WORLD WAR II MEMORIAL: FDR D-DAY PRAYER DESIGN DEVELOPMENT

PRESENTATION TO THE NATIONAL
CAPITAL PLANNING COMMISSION

Letter Re: FDR Prayer Concept

CFA 21/APR/21-1

Revised Planting Design

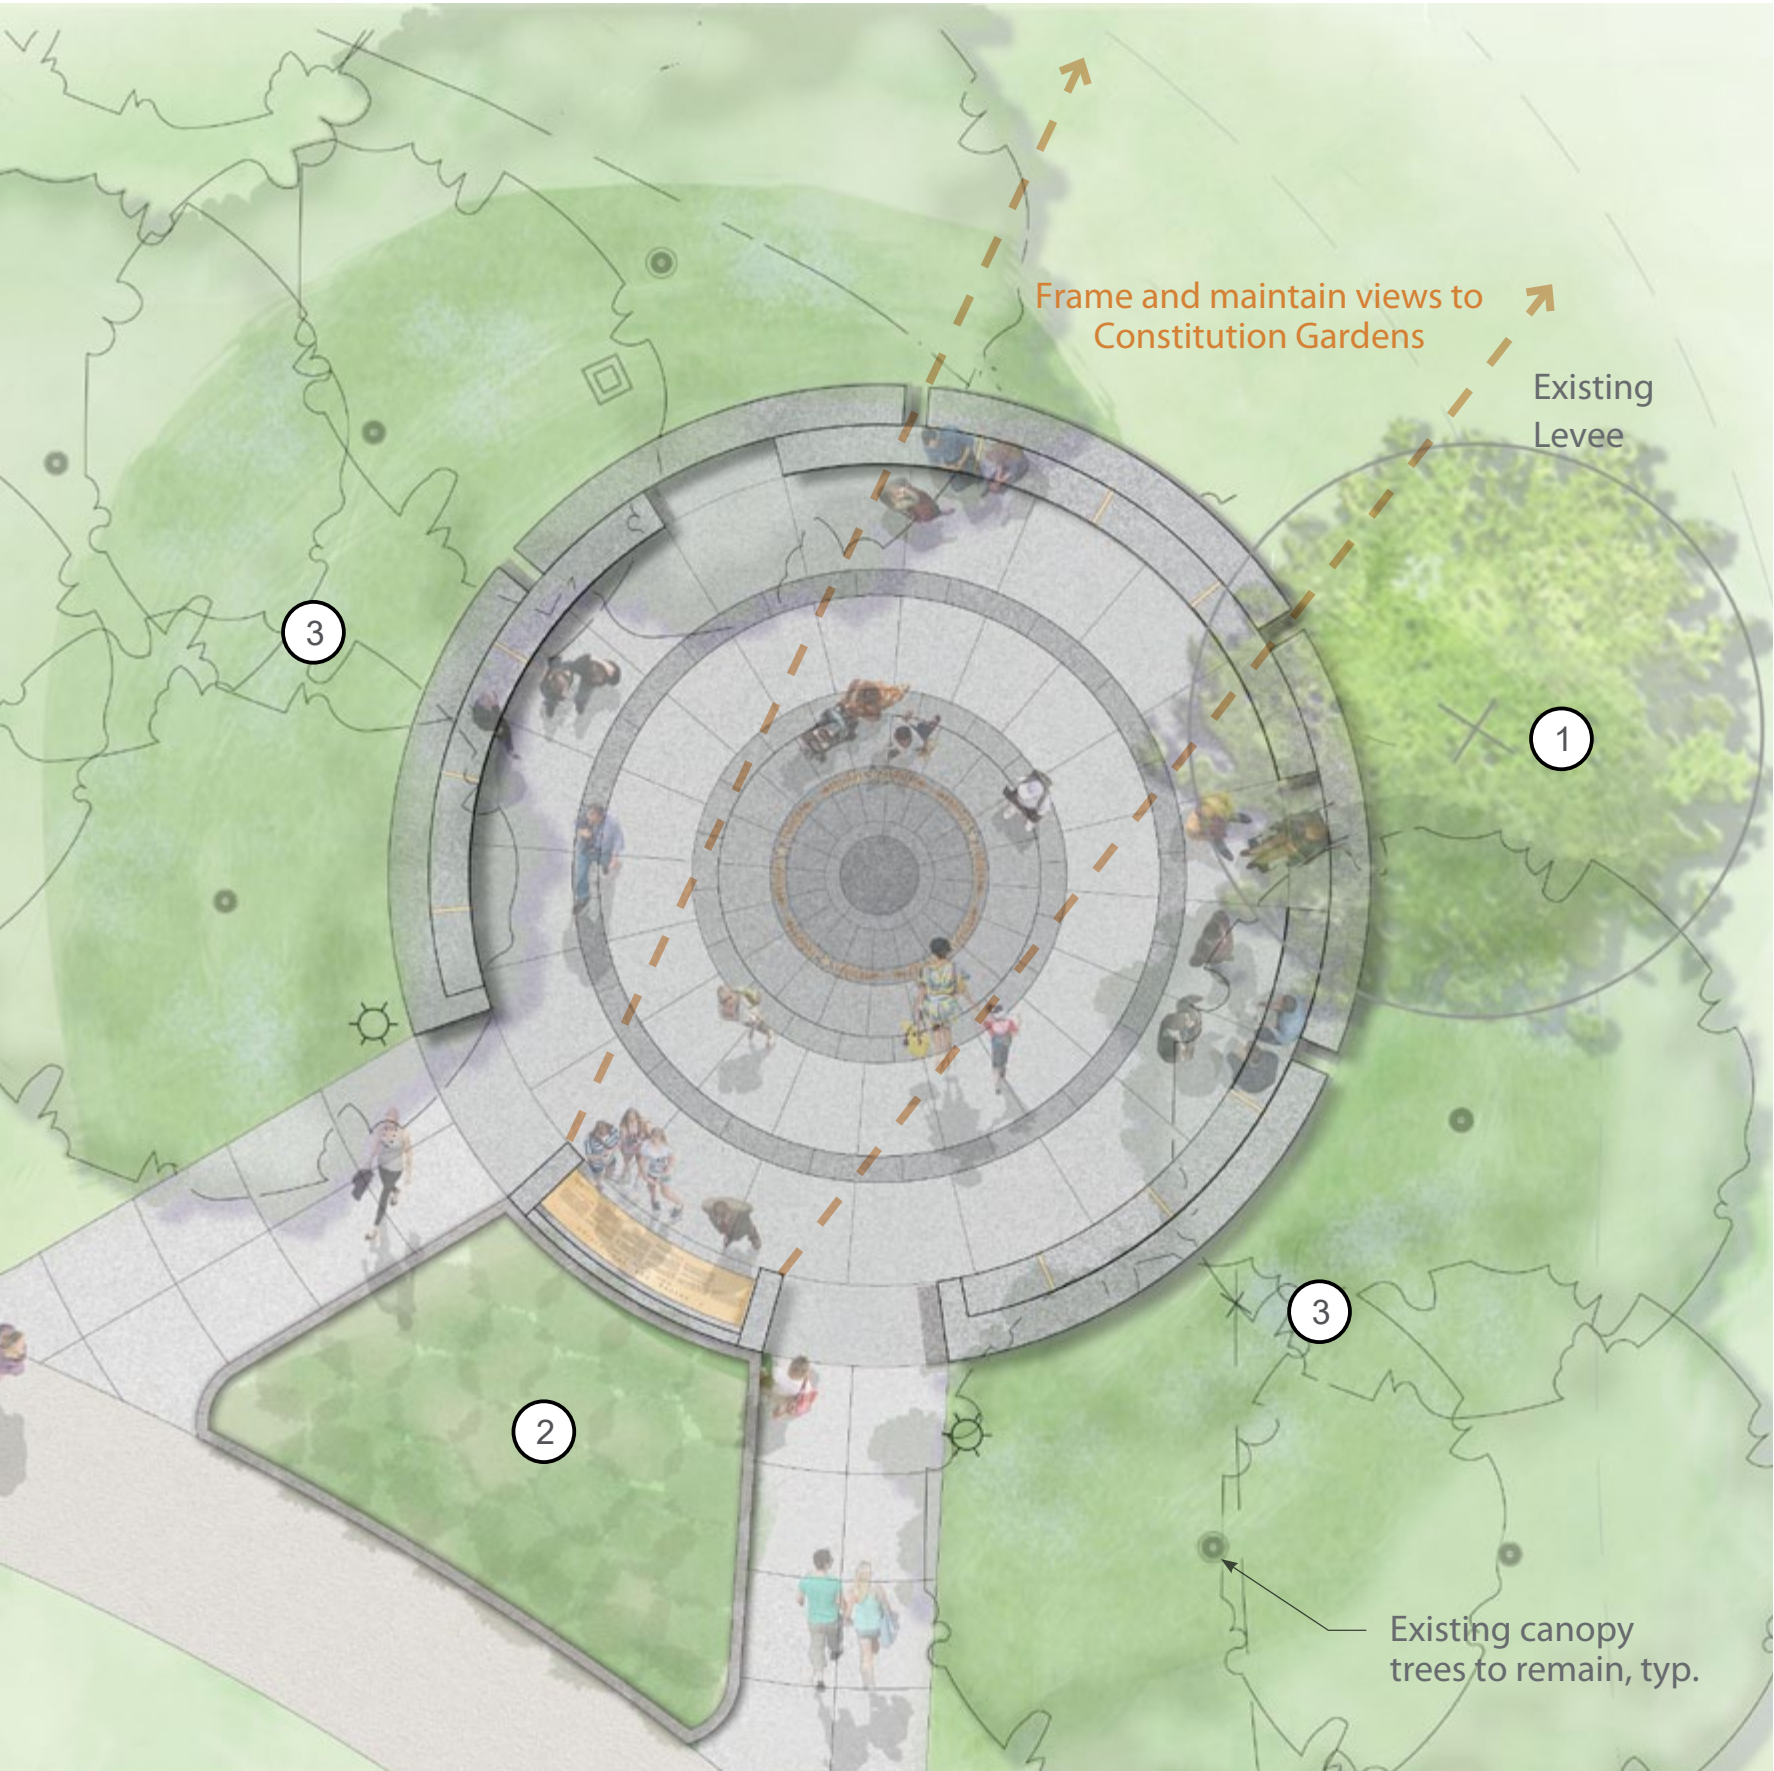
“simplifying the plantings...to unify the site with the larger landscape of the war memorial”

- Retain existing trees
- Place (1) additional Chionanthus retusus to balance design
- Low evergreen shrubs at entry: Sarcococca hookeriana var. humilis

① Additional Chionanthus retusus to match existing multi-stem trees

② Front Entry Shrub: Sarcococca hookeriana var. humilis

③ Groundcover under trees: Carex species

Bench Studies

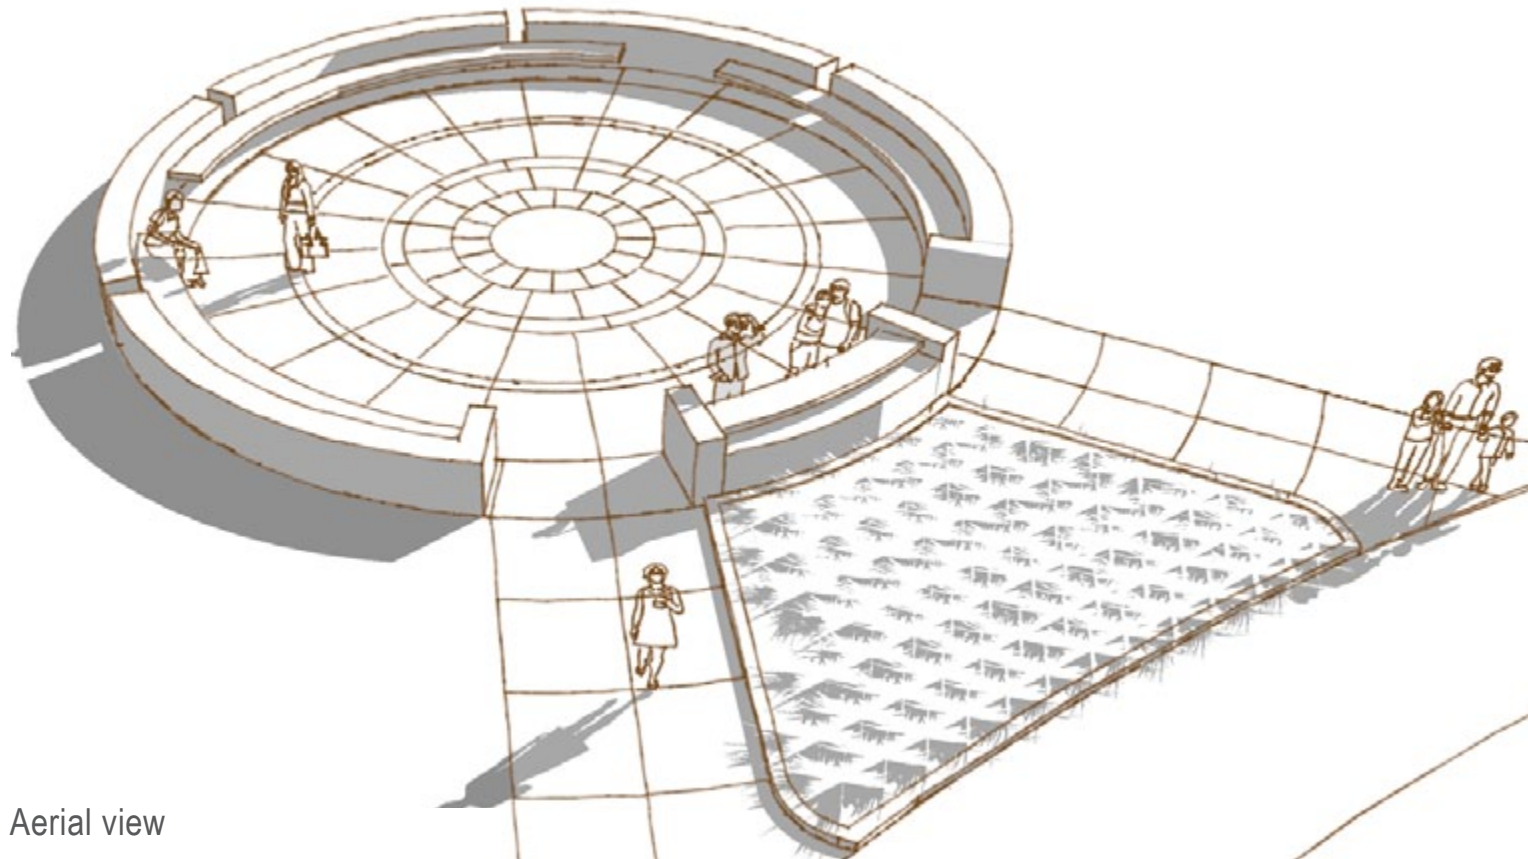
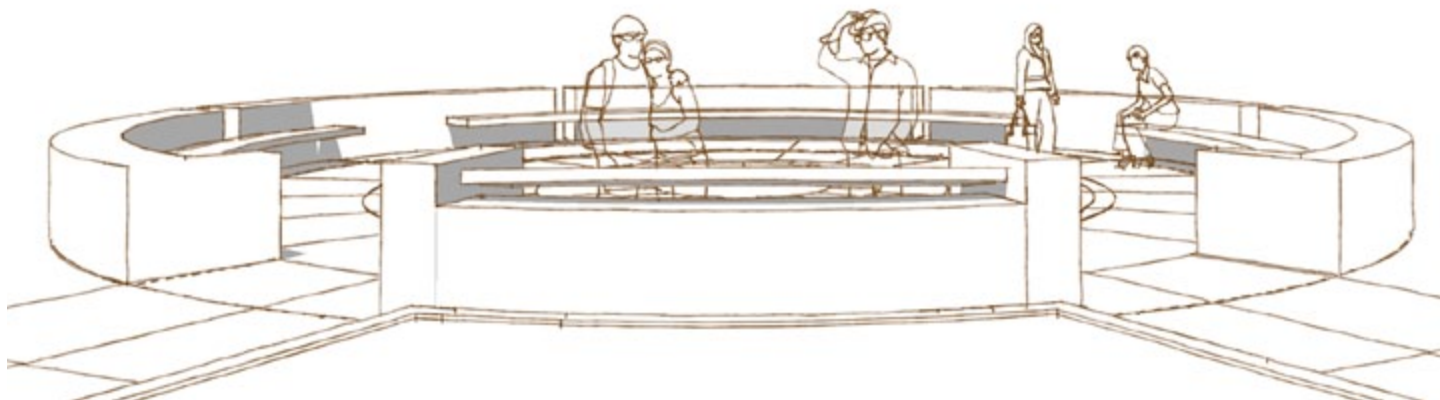
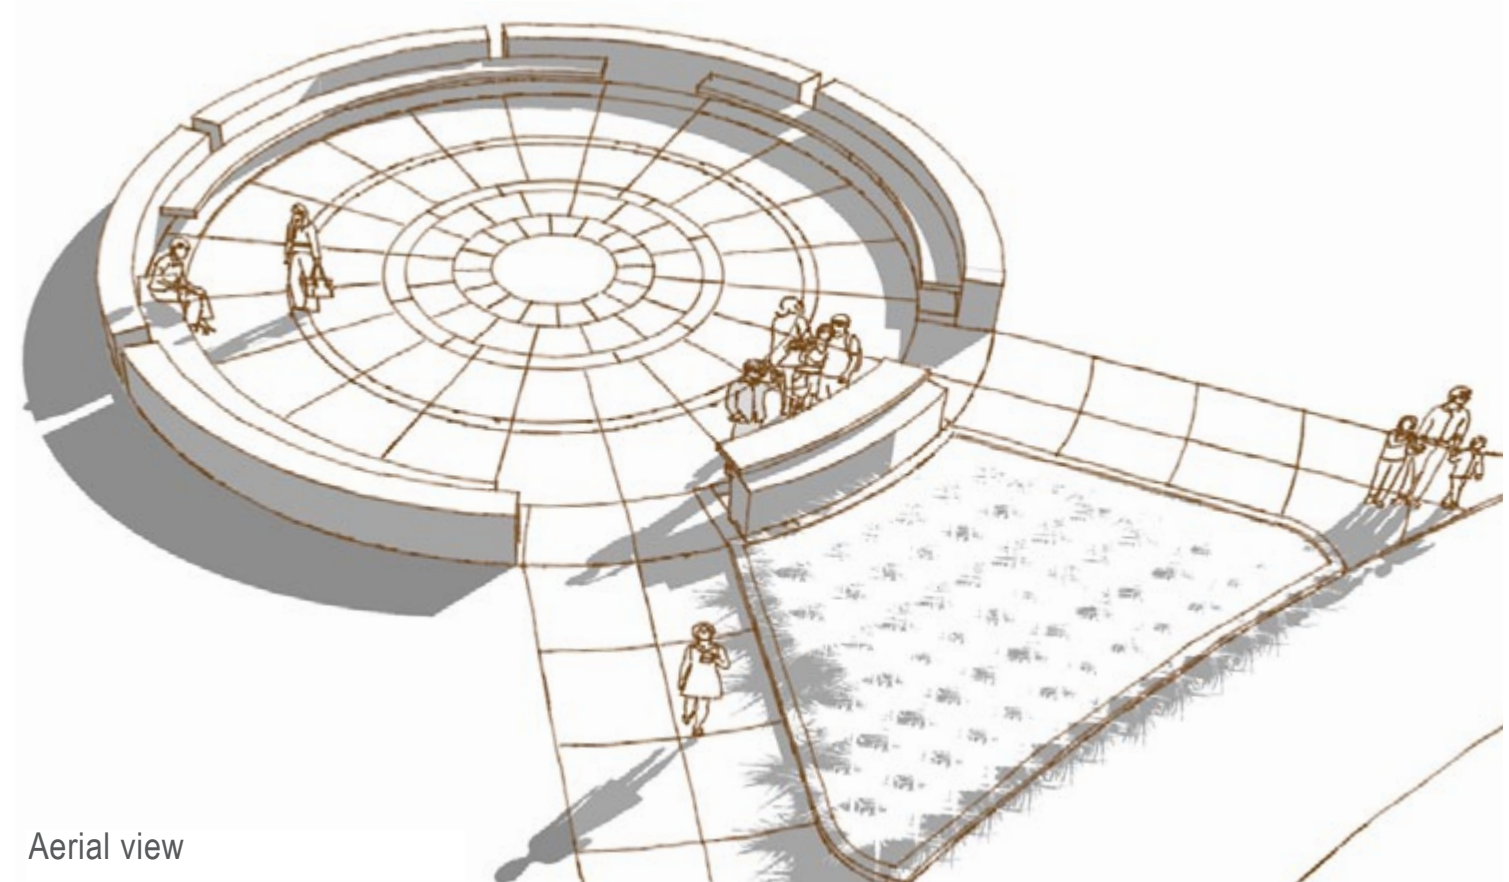
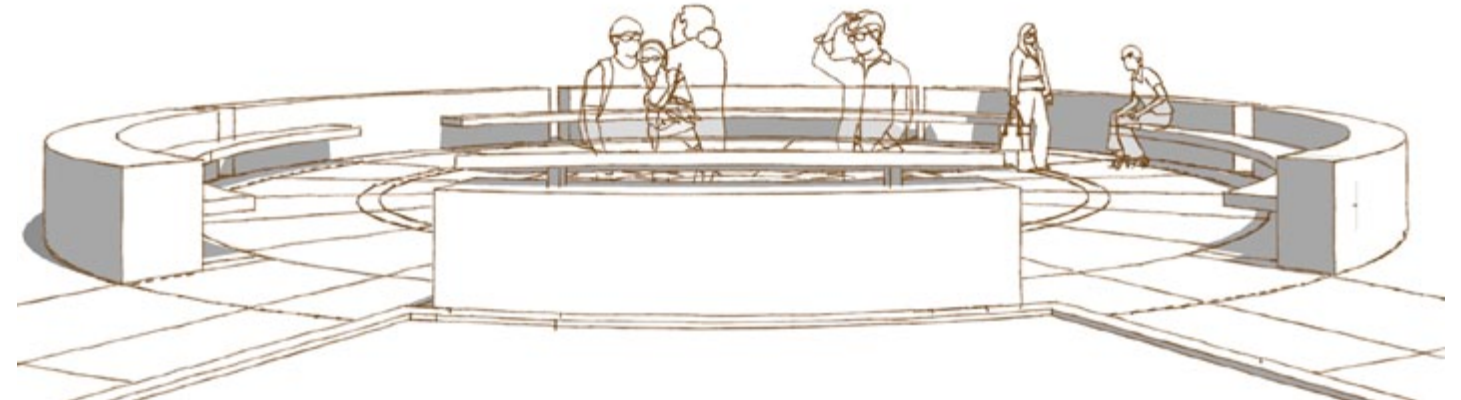
In previous review, Commission recommended “the design of the perimeter benches be less blocky in character, perhaps more carefully related to the benches within the central area of the memorial.”

- Pillars eliminated and bench sculpted in revised design
- Pillars removed from Plaque enframement, allowing the Prayer to ‘float’
